City of Portland, Oregon
Bureau of Development Services
Land Use Services

NOTICE OF A TYPE II DECISION ON A PROPOSAL IN YOUR NEIGHBORHOOD

CASE FILE NUMBER: LU 09-107812 TR

Case Type: TR (Tree Review)
Procedure: Type II, an administrative decision with appeal to the Hearings Officer.

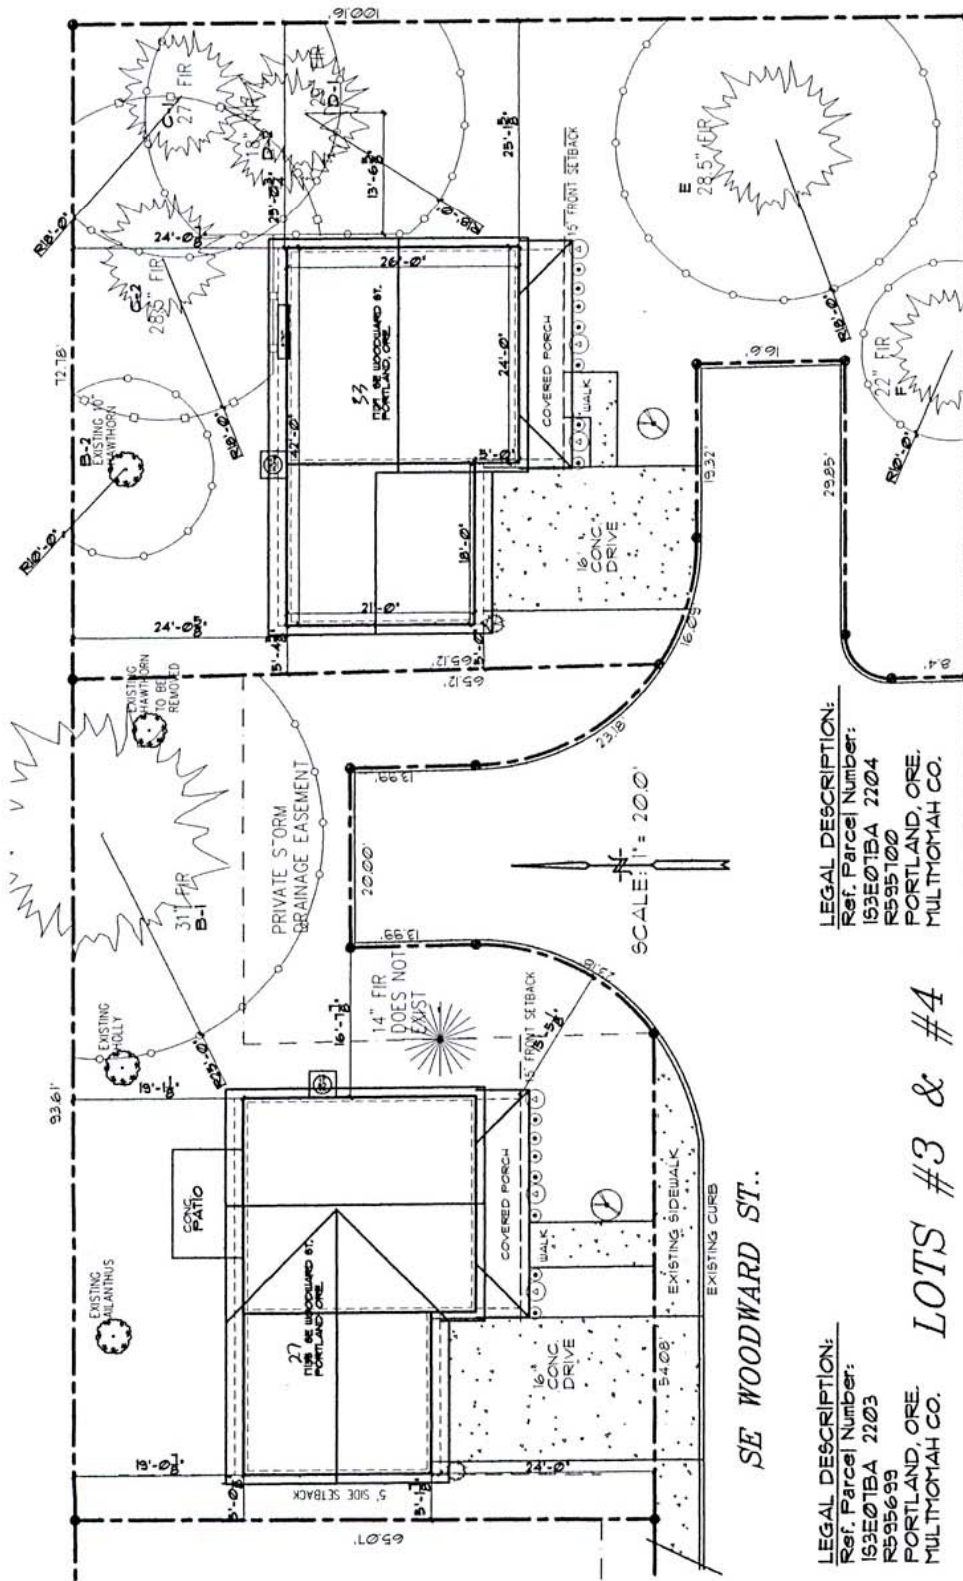
Please See pages 7-8 of this report. Arborist reduced RPZ of trees C-2, D-1, D-2 to 10' on west of D-1 + D-2, and 10' to South of C-2

It is my opinion that the minimums of ten to eighteen feet radius of fencing (-from tree bases) will adequately preserve these trees. Note that tree F is the only tree that gets a ten foot radius. Trees D-1 and D-2 get 18' on their southern sides, diminishing to 13'6" on the western side, toward the house foundation. As mentioned, it is my opinion that this is enough RPZ due to the root space these two larger trees have in common. It is a smaller root protection zone than normally recommended. In my opinion, with the shared root space and wind buffering of this grove, the smaller RPZ's will work.

arborist
.09-107812_001.pdf

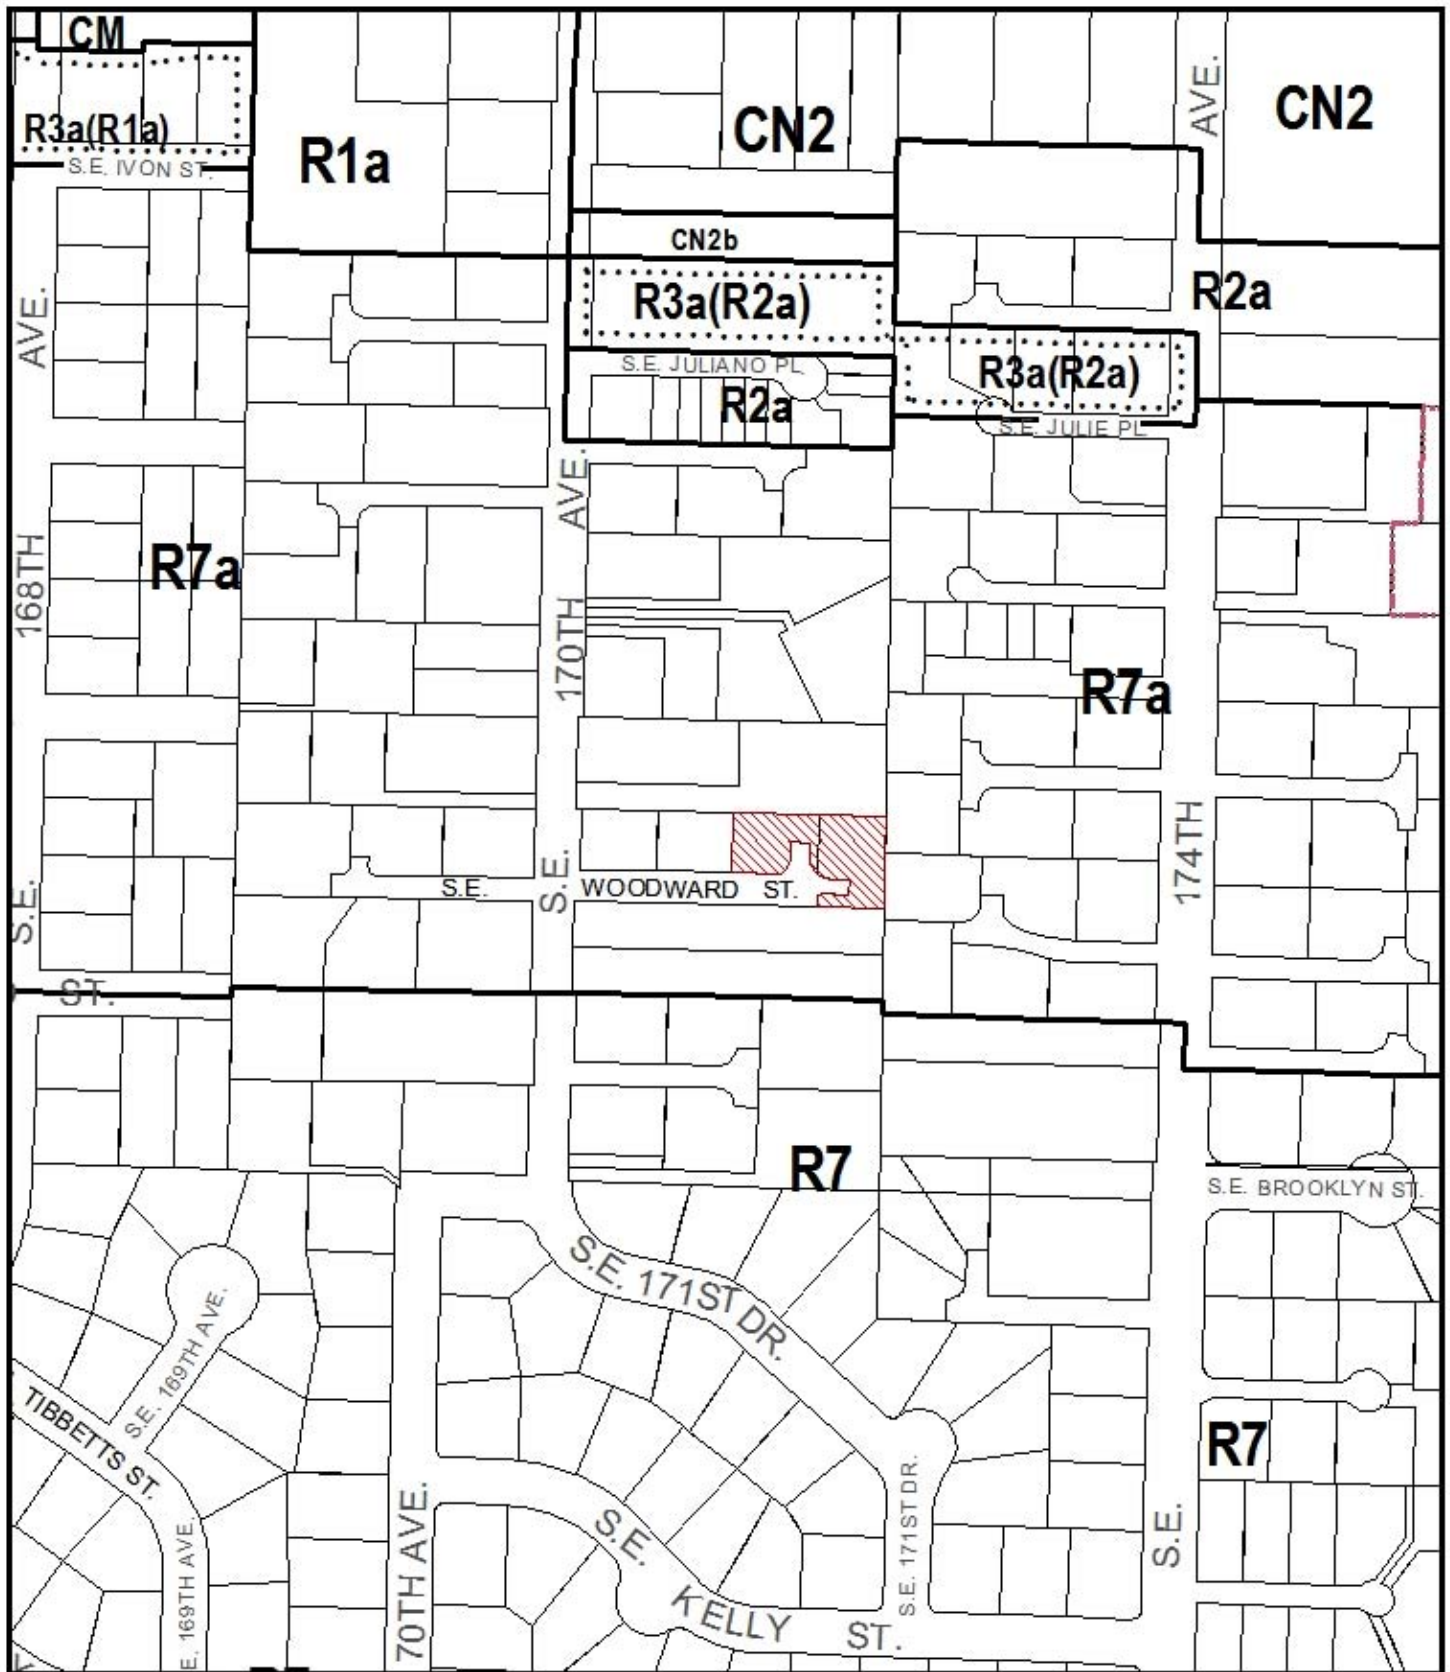
Please see the attached arborist report/site plan (page 7 of attachment) that I got from you and the applicant. The current recommended root protection zone for trees listed as C-1, C-2, D-1 and D-2 have RPZ's that extend directly to the foundation of the proposed house on lot 4, which would make it almost impossible for the construction workers to work on the east/northern facade of the house proposed without going into the protective fencing shown at the RPZ of the protected trees mentioned above. The City's new protective fencing regulations require metal fencing with steel posts, making it harder to move around protective fencing once its installed.

You mention on page 4 of the attached report that all trees being preserved should have a minimum of 10 feet of site area surrounded by protective fencing. I just wanted to get something a little more explicit in regard to trees C-1, C-2, D-1 and D-2.

Do you think it would be ok to move the location of the RPZ (and the protective fencing required) for trees C-1, C-2, D-1 and D-2, 3 to 5 ft. farther from the foundation of the proposed house than is recommended in the attached report? This would provide the minimum 10 ft. root protection zone separation between the proposed house and the trees in question, and would also provide the builders some room to work on the eastern and northern facades of the house without impacting the protective fencing required.

Hello, Shawn, I do think it will be viable to change those RPZ's, especially since, as you mention, fencing standards have changed to steel since we started this process, and are better for tree protection. In short, all four of those trees mentioned will have a shared, protected root zone which I am counting on to protect them better than single circled RPZ's would.
